**SUBJECT: NEW VEHICLE DEMONSTRATION / DELIVERY HOLD - Safety Recall 17S15  
 – Supplement #4**

Certain 2015-2017 Transit Vehicles Equipped with a Driveshaft Flexible Coupling  
 Driveshaft Flexible Coupling Repair

**New! REASON FOR THIS SUPPLEMENT**

- *Affected Vehicles: An additional 64 vehicles have been added to this recall.*

FIGURE 7

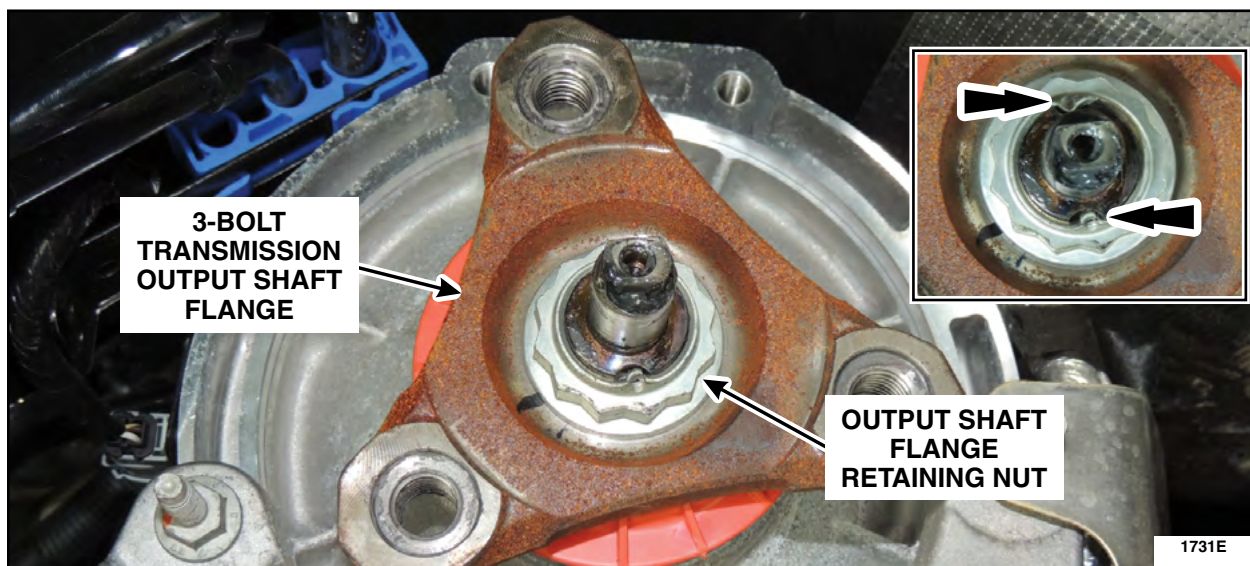
1. Remove the Driveshaft. Please follow the WSM procedures in Section 205-01.
2. Using a 1/2" drive, 34mm, 12-point deep socket, remove and discard the 3-bolt transmission output shaft flange retaining nut and flange. (See Figure 7):

**NOTICE: The output shaft flange retaining nut has been staked to prevent it from coming loose. Prior to removing the nut, remove the stake to prevent damage to the output shaft.**

- a. Remove the output shaft flange retaining nut stakes.
- b. Place the vehicle in the PARK position and remove and discard the output shaft flange retaining nut.
- c. Remove and discard the 3-bolt transmission output shaft flange.

FIGURE 8

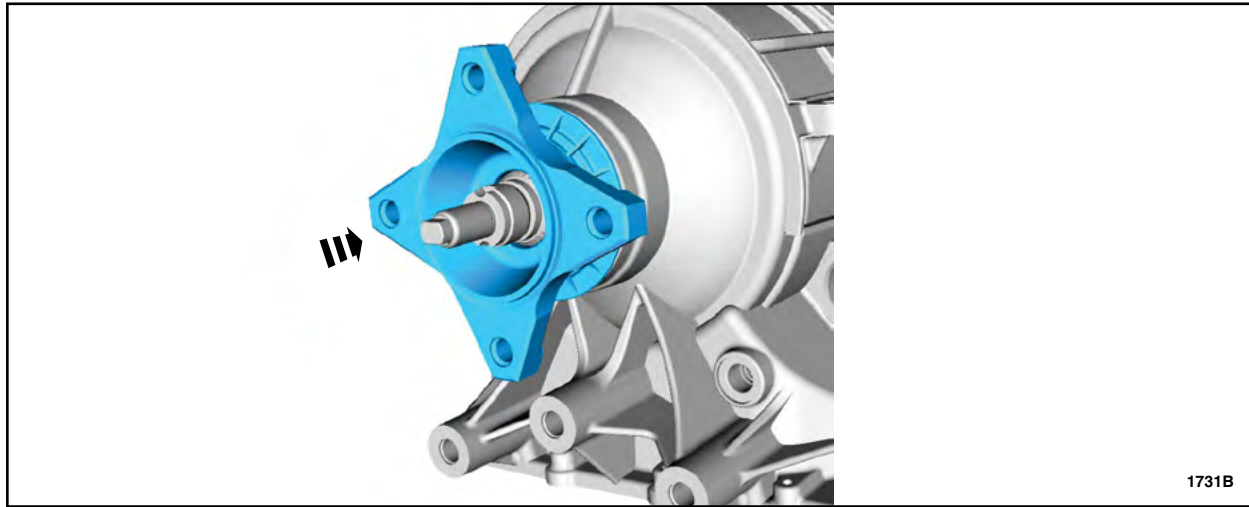
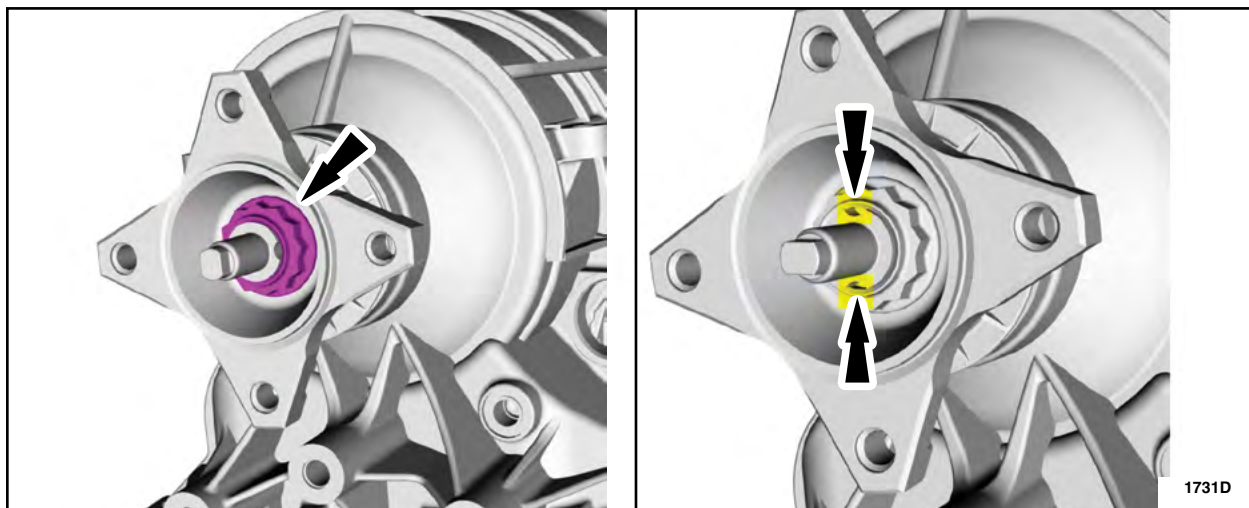
- Using a 1/2" drive, 34mm, 12-point deep socket, install a *new* 4-bolt transmission output shaft flange and retaining nut. (See Figures 8 and 9):

**NOTICE:** The output shaft flange retaining must be staked to prevent it from coming loose.

- Install a *new* 4-bolt transmission output shaft flange.
- Install a *new* output shaft flange retaining nut.
  - Tighten nut to 59 lb.ft (80 Nm).
- Stake the output shaft flange retaining nut.

**FIGURE 10**

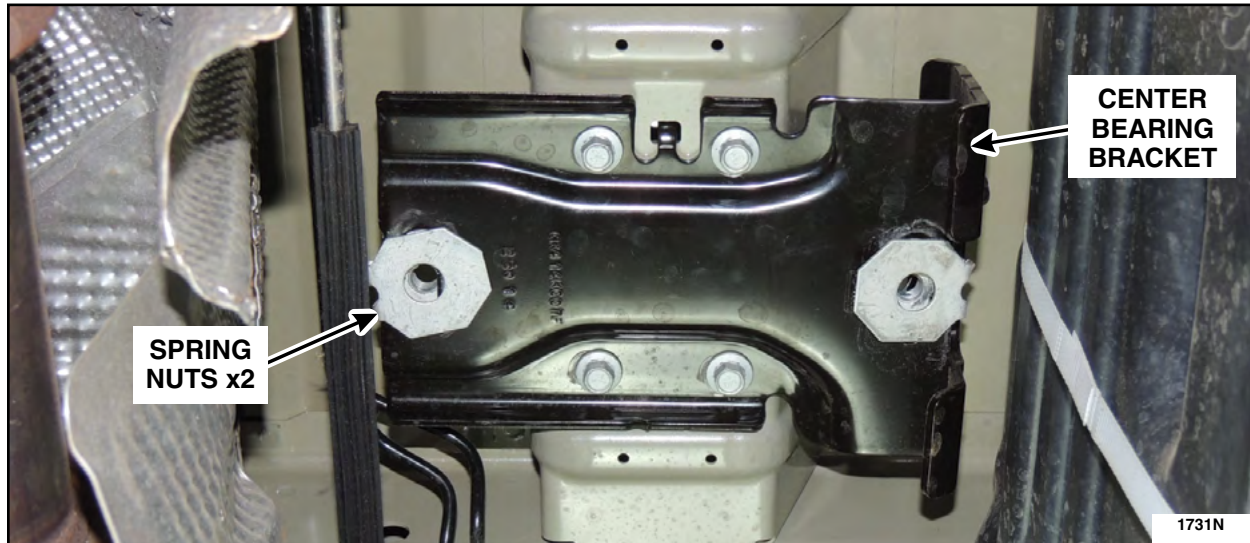
1. Remove and discard the four center bearing bracket retaining bolts and the center bearing bracket. See Figure 10.

**NOTE:** Original center bearing bracket shown, *new* bracket is similar.

2. Install the center bearing bracket spring nuts onto the *new* center bearing bracket.
3. Install the *new* center bearing bracket using four *new* retaining bolts. See Figure 10.
  - Tighten bolts to 18 lb.ft (25 Nm).
4. Proceed to the next required Permanent Repair Service Procedure.

FIGURE 14

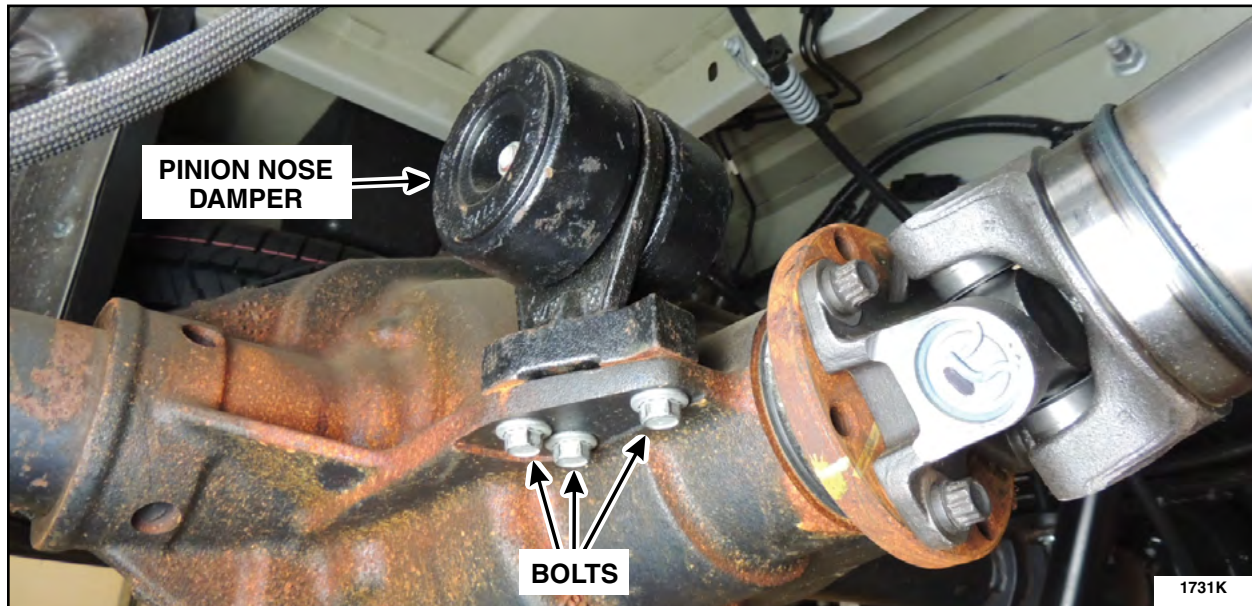
1. If a pinion nose damper is present, remove and discard the three bolts and the original pinion nose damper located on the RH side of the rear axle center housing. See Figure 14.
2. Install a *new* pinion nose damper and tighten the three bolts. See Figure 14.
  - Tighten bolts to 46 lb.ft (62 Nm).

**NOTE:** Original pinion nose damper is shown. *New* pinion nose damper may appear similar to the original (if equipped), but the dampening characteristics have been changed.
